Subject: Seismic and Structural Design Analysis Audit
Docket Nos. 50-361 and 50-362
San Onofre Nuclear Generating Station
Units 2 and 3

Enclosures: (1) Partial Response to Audit Request Items
(2) Audit Request Item Submittal Schedule

NRC STRUCTURAL AUDIT REQUEST ITEMS

FIGURE 1
 C₂ FACTORS FOR VERTICAL
 TRANSLATION MODE

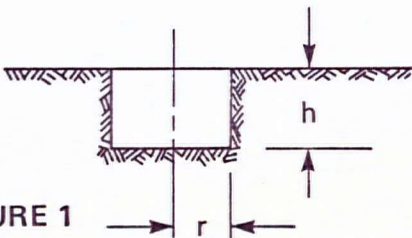
Item Provide justification for the value of correction factor C_2 used for calculation of horizontal spring constants.

For the SONGS site large scale model tests were conducted by WCC (Woodward-Clyde Consultants) by setting five concrete slabs of different size, shape and embedment configurations into transient motion and measuring the response of these slabs. The slabs ranged from 4 to 10 feet in diameter and 2 to 5 feet in thickness. Details of these tests and their results are described in Appendix 3.7C of the FSAR. Most of the results obtained from these tests were for an embedment ratio of approximately 1. C_2 factors for other embedment ratios were developed by utilizing the form of C_2 versus h/r relationship developed by Kaldjian by normalizing that form to the result of the field tests described above. C_2 factors thus developed for vertical translation are presented in Figure 1. The figure also shows C_2 factors developed by Stokoe, Novak and Beredugo, and Dominguez, also normalized to the results of the field tests described above. In addition, the figure also shows the +30% variation in soil stiffness used in the actual analysis for soil-foundation interaction studies for the site.

It is noted that the C_2 factors developed by the various investigators as described above, fall within the range used for the actual analysis.

FIGURE 2 – SCHEMATIC FOR DETERMINING CIDP FROM DISPLACEMENTS

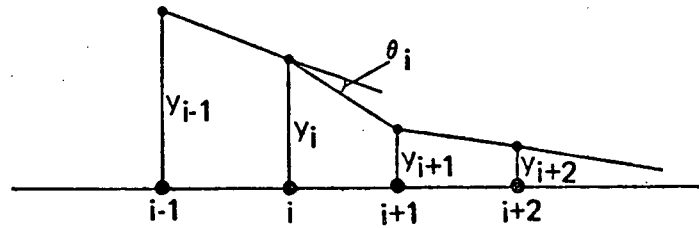
Item #1 Provide more details of modeling techniques used in the CIDP analysis including boundary condition assumptions. Describe how the method accounts for varying stiffnesses of different structures.

on the basis of available information for the soil and structural elements. Dynamic properties of soil elements were based on results of field and laboratory tests presented in Appendix 3.7C of the FSAR and accommodated strain dependent behavior. Dynamic properties of structural elements represent an approximation of the actual structural geometry when represented by plane-strain finite elements. The elastic modulus of the solid model element is determined such that its overall stiffness approximates that of the box-shaped concrete element it represents. These values of modulus were developed based on joint input from Bechtel, Edison and WCC regarding the overall size and thicknesses of structural elements and their dynamic behavior in the finite element model. A schematic finite-element model of soil structure system is shown in Figure 1a.

The CIDP is determined by examining θ_i at all nodal points and all times t . The displacement profile with maximum θ_i is considered to be the CIDP.

FIGURE 1

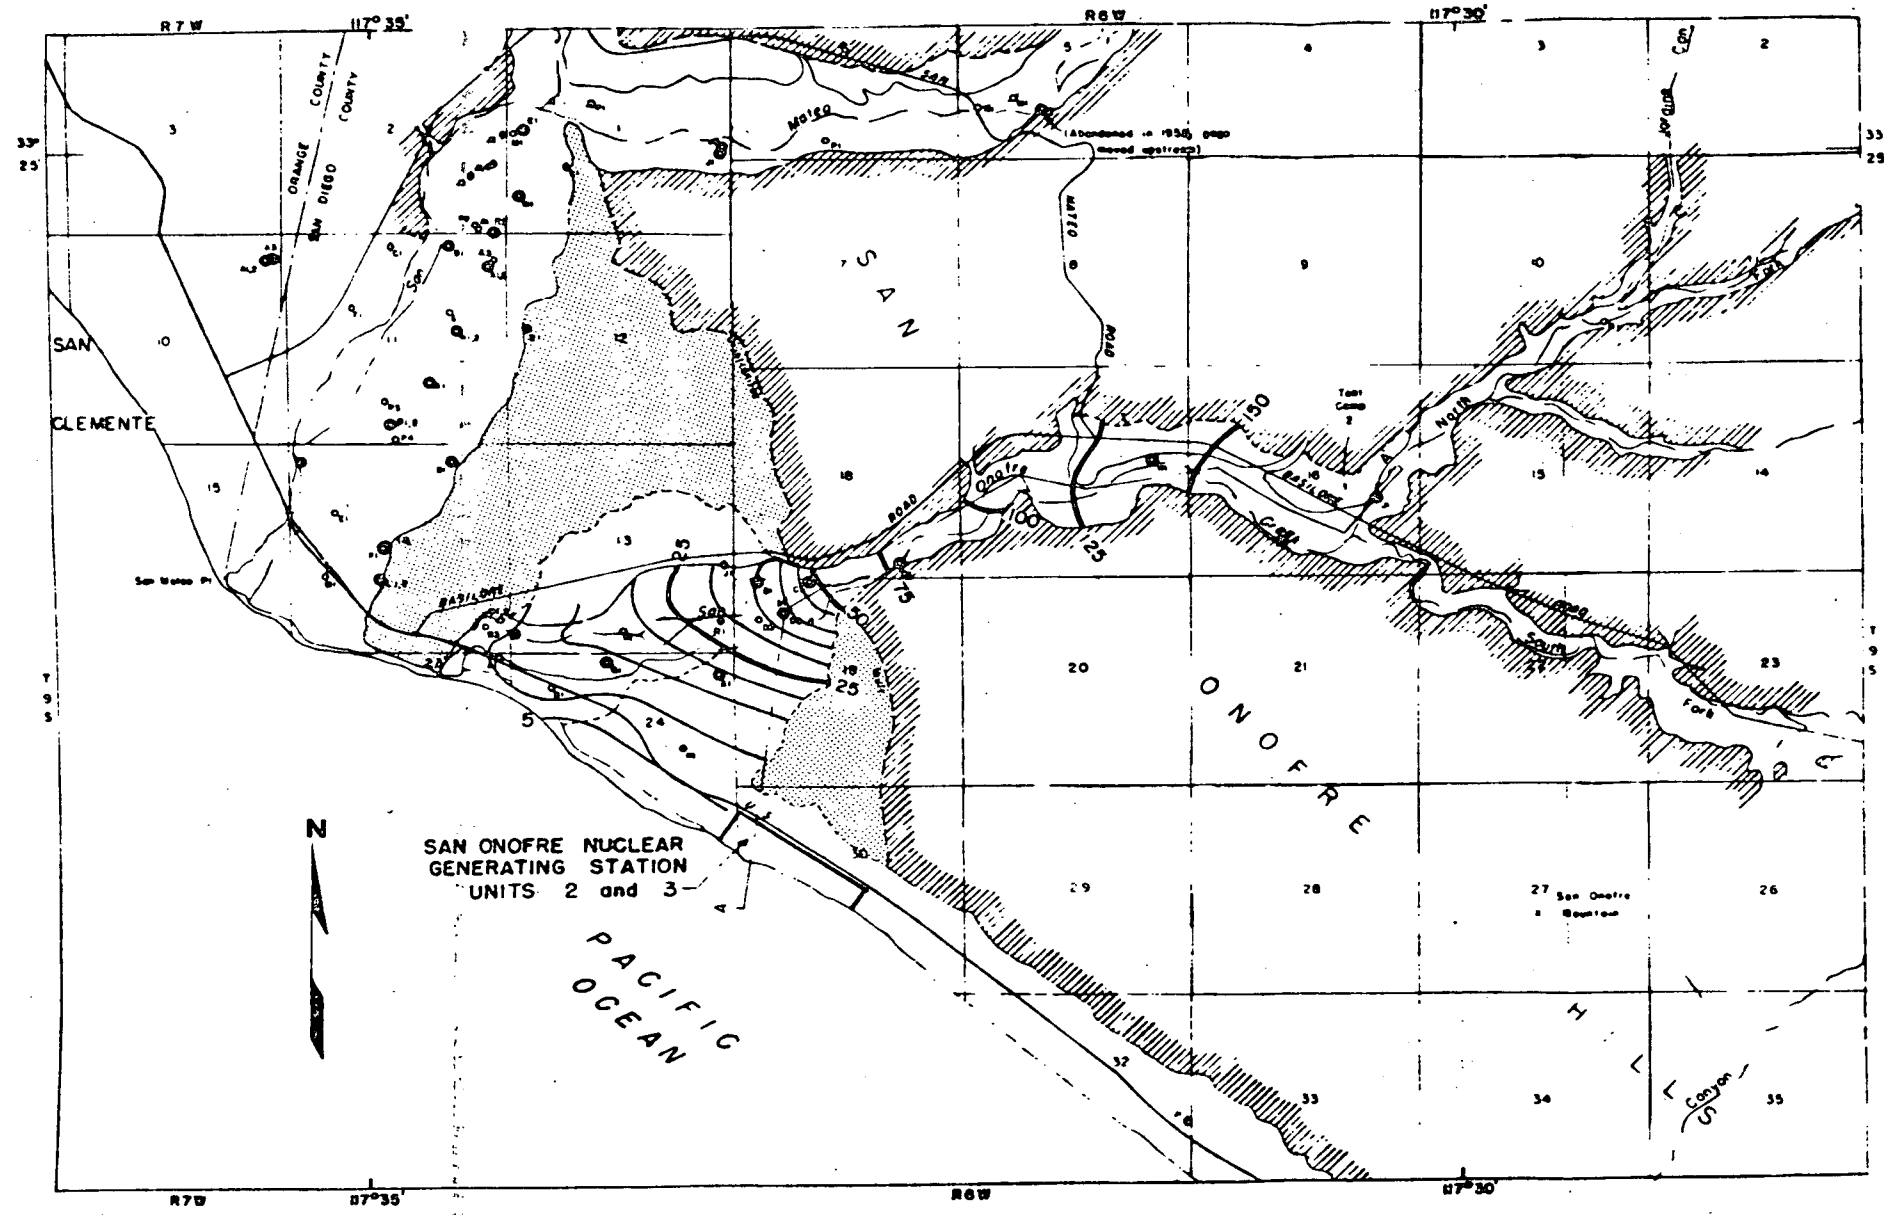
Item #2: Provide basis for establishing the maximum ground water level used in determining hydrostatic pressures on structural walls.

(1) ground water contours for typical high and low ground water conditions are presented in Figures 2.4-27 and 2.4-28 of the FSAR (presented as Figures 2 and 3 here for completeness) indicate a maximum ground water elevation of +5 feet in the immediate vicinity of the site; and (2) a

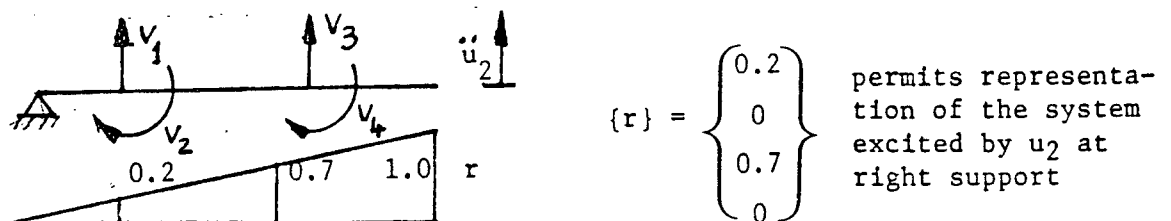
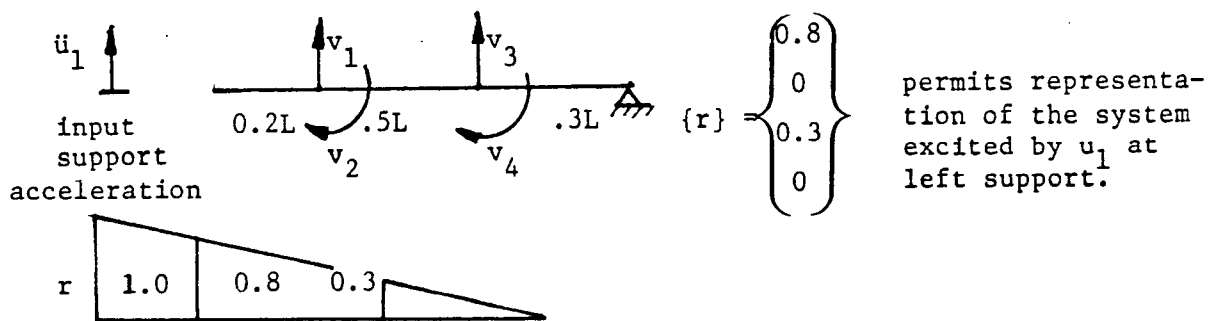
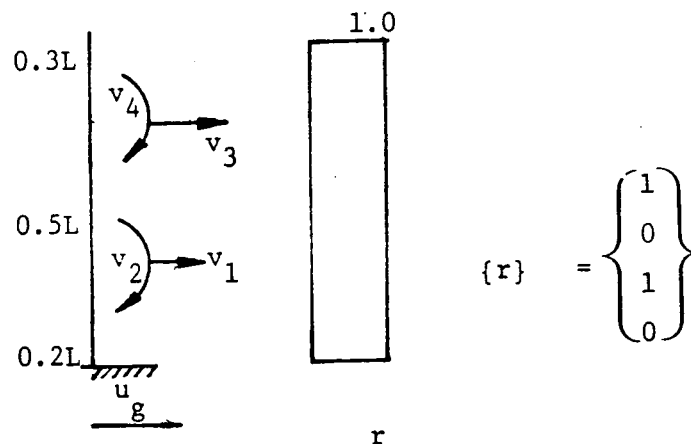
Item #2: Provide description of procedure used in design of the auxiliary building truss utilizing SMIS computer program considering multiple point response spectral input.

The dynamic analysis of the control room roof truss was performed by modal response spectra analysis, using, as inputs, motions defined by vertical in-structure response spectra calculated at the two support points of the truss. This analysis considered only vertical response since the truss is fully supported horizontally at the top and bottom by floor diaphragms and its horizontal response was evaluated in the overall analysis of the concrete structural system. For vertical response, the support points were defined by the top of the concrete wall on one side, and the bottom of the column on the other side. The two-dimensional model for the truss was developed, using beam elements which accounted for the axial loads and bending moments that developed in the heavily welded members of the truss. The steel column was included in the truss model. The dynamic analysis and the matrix formulation were both performed using the SMIS computer program.

At each of the support points of the truss, different in-structure response spectra were used. These exhibited different response characteristics due to the variable stiffness characteristics of the supports. On one end, the

Where, all the terms in this equation are per the usual definition, including the $\{r\}$ transformation matrix which according to its fundamental definition is used to scale and to define the degrees of freedom that are parallel to the input base motion $\{u\}$. The application of the transformation matrix is illustrated as follows:
